Form C-103
Revised July 18, 2013

WELL API NO. 30-025-42760	
5. Indicate Type of Lease STATE ☐ FEE ☒	
6. State Oil & Gas Lease No.	
7. Lease Name or Unit Agreement Name Brininstool SWD	
8. Well Number 1	
9. OGRID Number 308339	
10. Pool name or Wildcat SWD; Devonian (96101)	
11. Elevation (Show whether DR, RKB, RT, GR, etc.) 3710' GR

Change to proposed interval as approved on C-101 APD

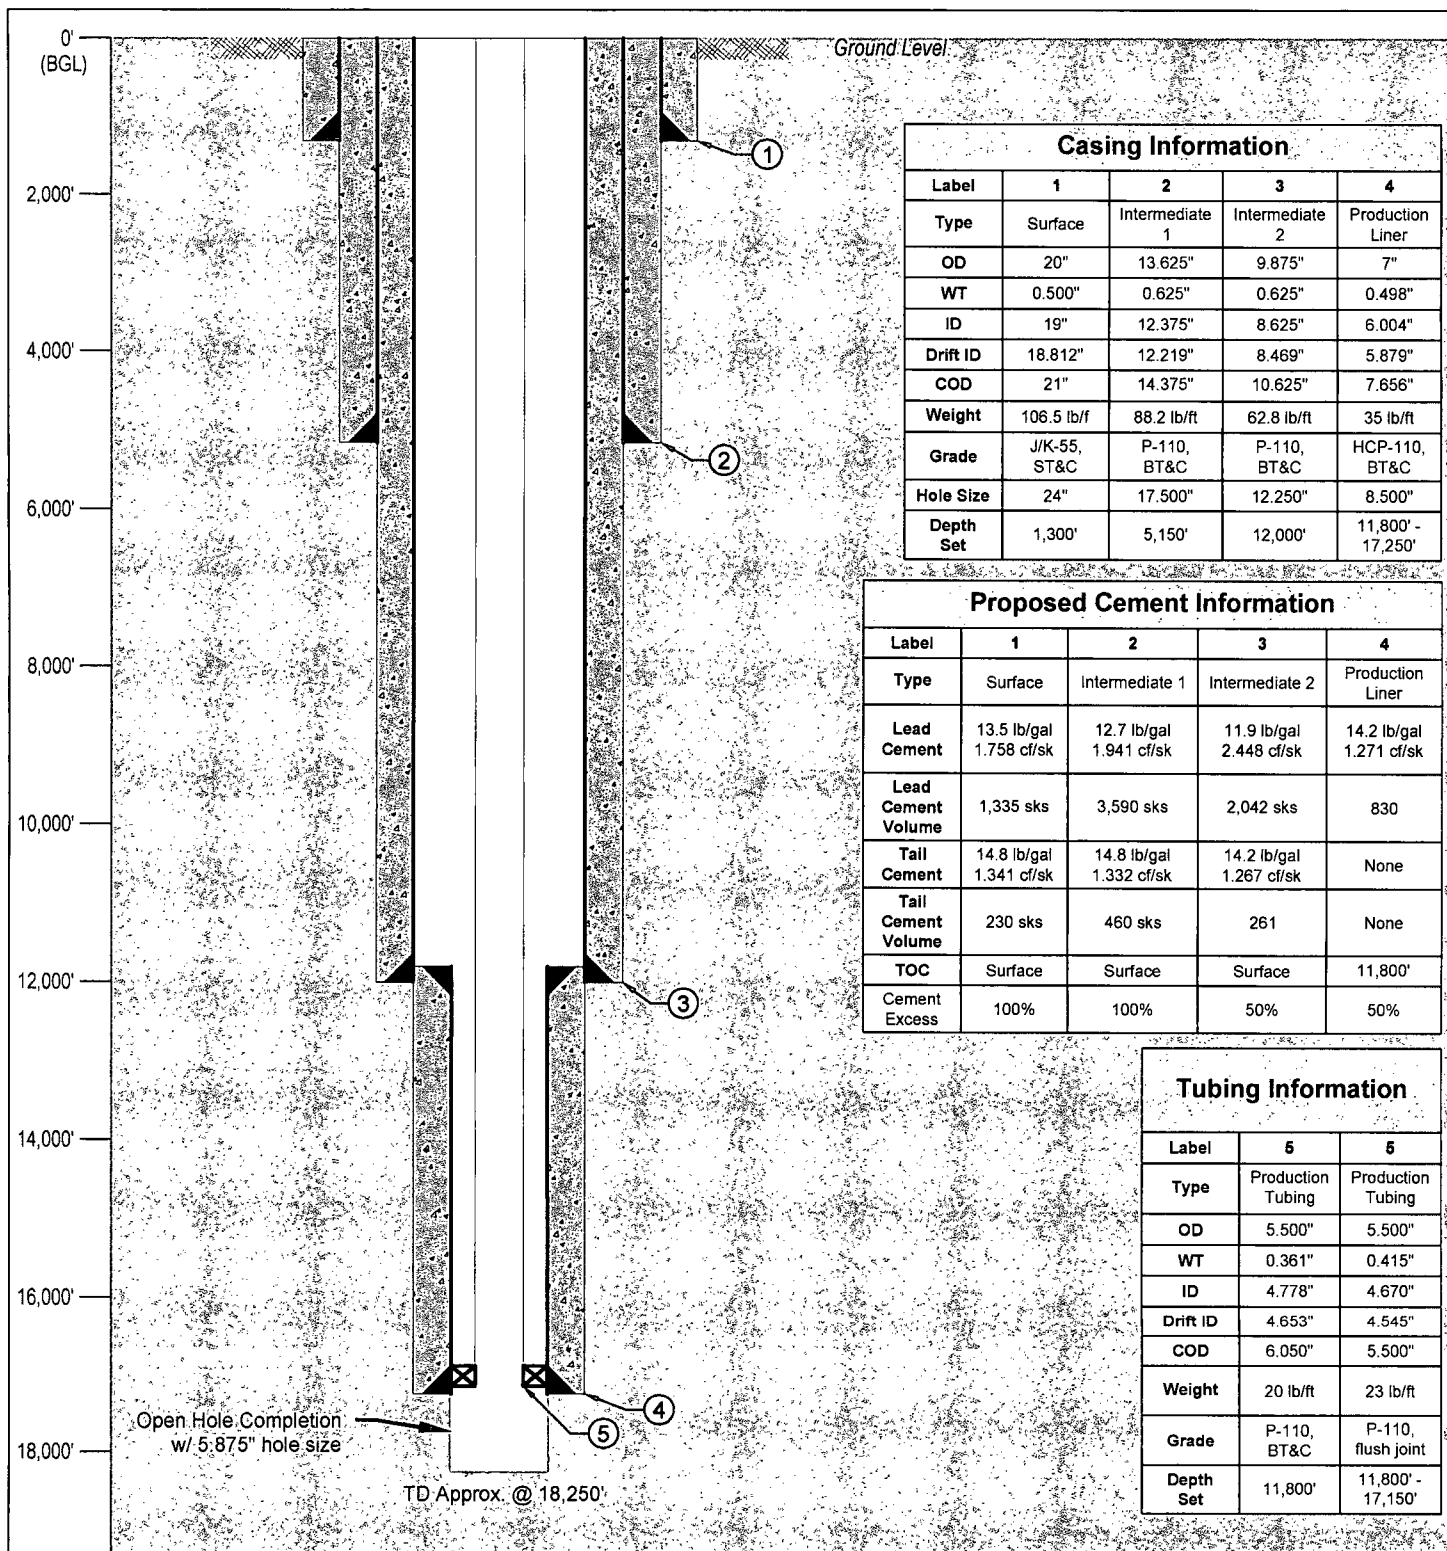
From that review, they determined a more appropriate maximum interval would be for a top of (casing shoe depth) 17,000 feet and a bottom hole depth of 18,500 feet with an ACTUAL TARGET depth of 17,250 feet to 18,250 feet.

Due to lack of geological control for this area and this depth, final interval depths will be determined by mudlogging while drilling and e-logs.

In this scenario, Owl hereby requests that a maximum permitted interval of 17,000'-18,500' be approved.

An updated Wellbore Diagram is attached.
